REQUEST

Current Zoning: NC (Neighborhood Center), N1-D (Neighborhood 1-D), and O-6(CD) (Office, conditional)
Proposed Zoning: CAC-1 (EX) (Community Activity Center 1, exception)

SUMMARY OF PETITION

STAFF RECOMMENDATION

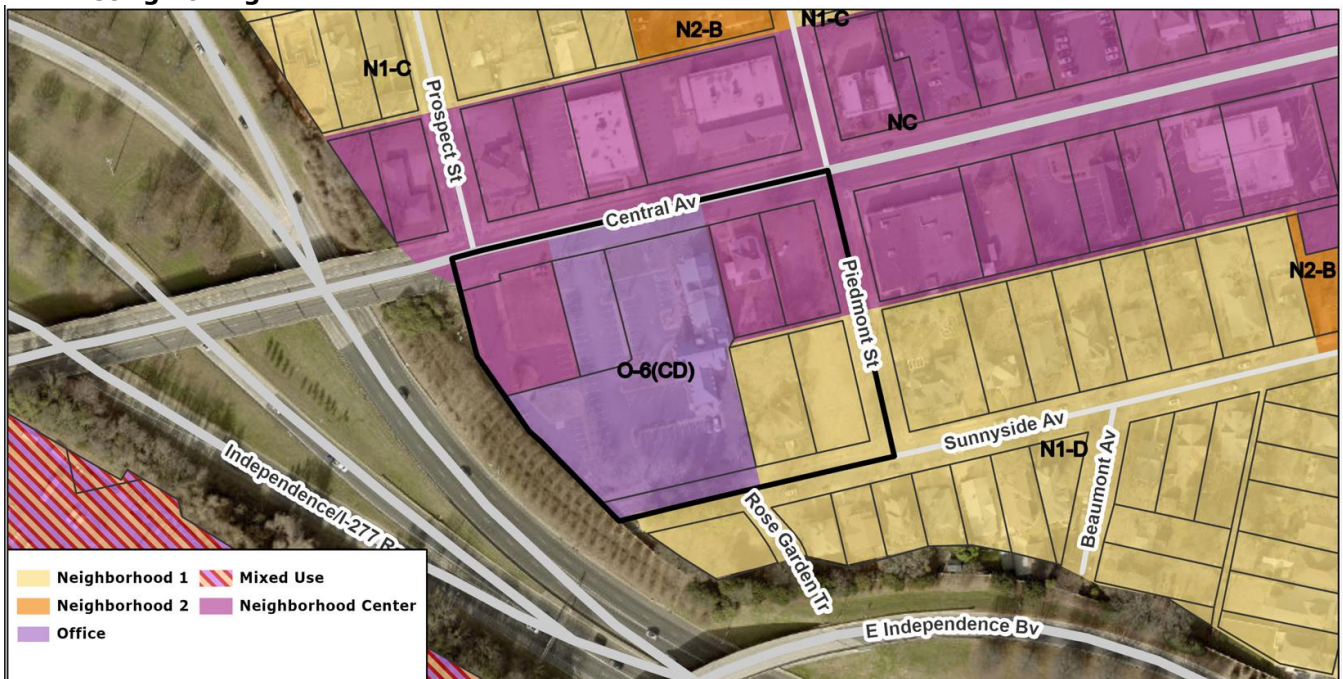
- ~~1. Revise the site plan to clearly show the limits of CATS infrastructure.~~ **Addressed**
